This document contains errata on the OCPP 2.0.1 documentation. These errata have to be read as an addition to the release of OCPP 2.0.1 Edition 2.

This is version 2024-02 of the errata. The errata of this version are marked with "(2024-02)" in the section title.

Figure 20: Sequence Diagram: Reset Without Transaction

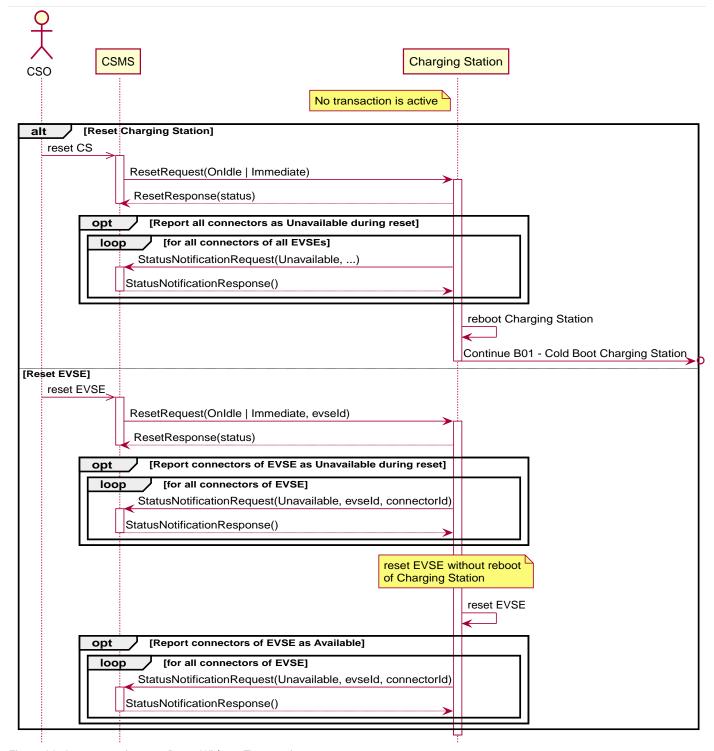
Page 65 - B11, Figure 20: Reset Without Transaction

The sequence diagram of Figure 20 has been updated to clarify the difference between reset of a Charging Station and EVSE.

Figure 21a: Sequence Diagram: Reset Onldle With Ongoing Transaction

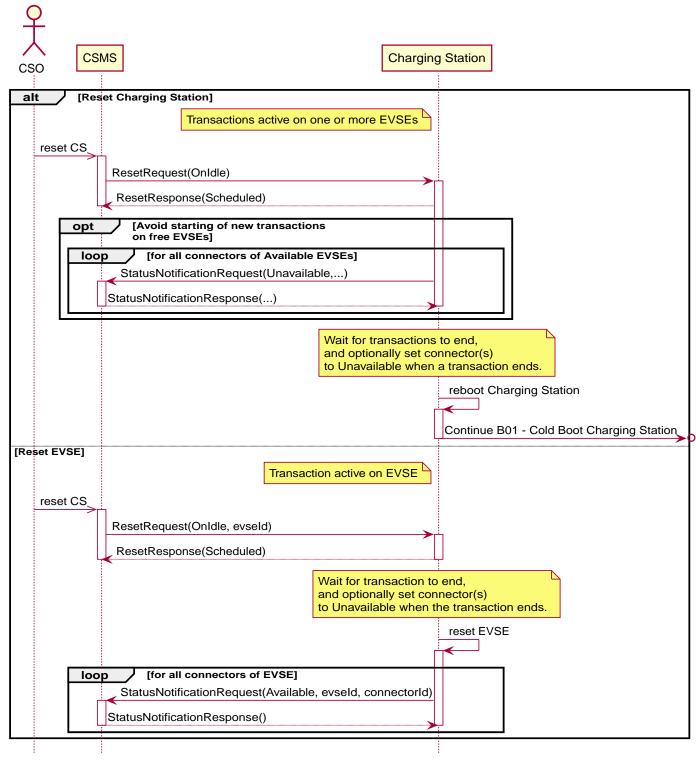
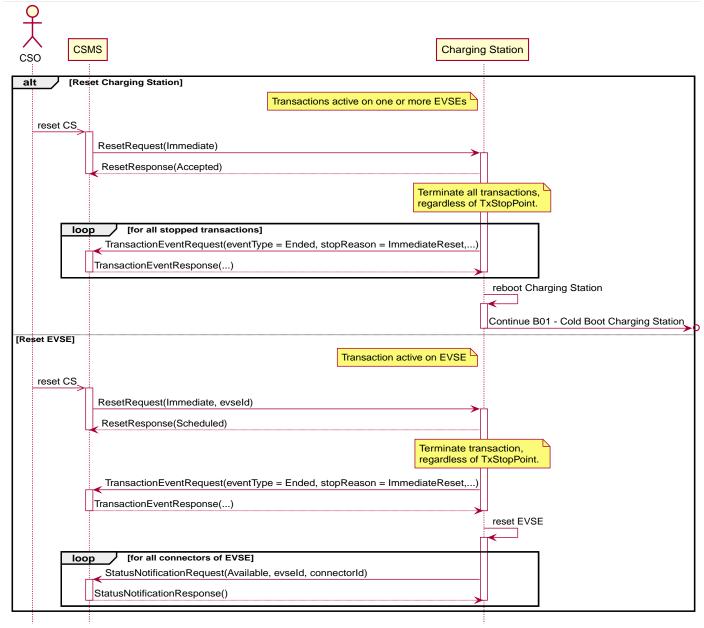
Page 68 - B12, Figure 21: Reset With Ongoing Transaction

The sequence diagram of Figure 21 has been updated to clarify the difference between a reset of Charging Station and EVSE. For clarity it has been split into two diagrams: one for Onldle and one for Immediate reset.

Page 96 - Update sequence diagram

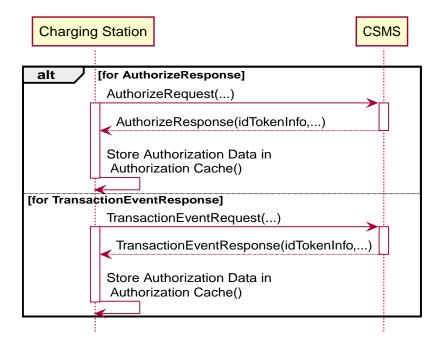
As a result of the above, the "for ReserveNowRequest" part has been removed from sequence diagram "Figure 31".

Figure 56. Sequence Diagram: Transaction locally stopped by IdToken with TransactionEventRequest reported strictly by TxStopPoint configuration

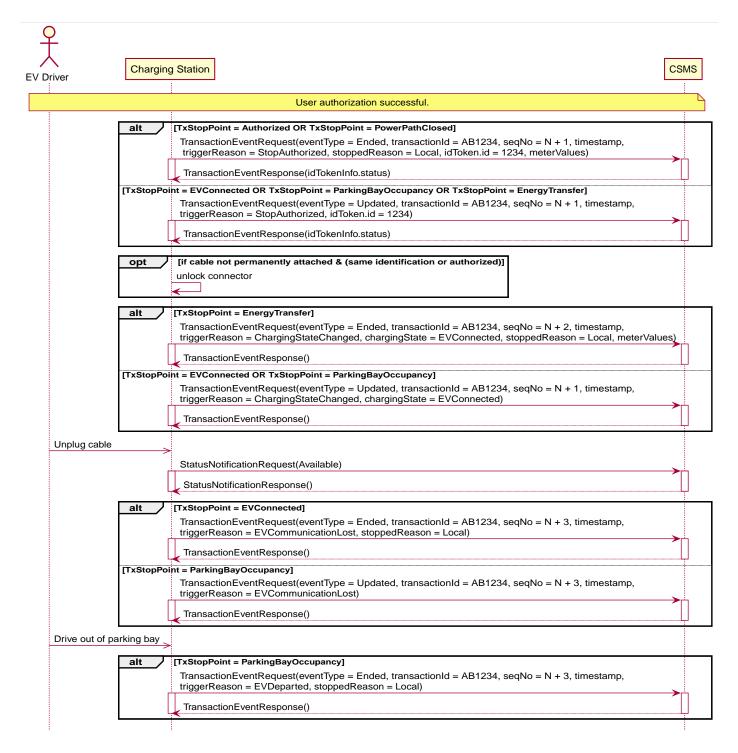
2.6.3. Page 148 - (2023-06) Use case E07: Wrong triggerReason shown in sequence diagram fig. 56 [687]

The fourth TransactionEventRequest in sequence diagram Figure 56 contains an incorrect *triggerReason* and should not have an *idToken*. Changed to *triggerReason* = ChargingStateChanged, *chargingState* = EVConnected.
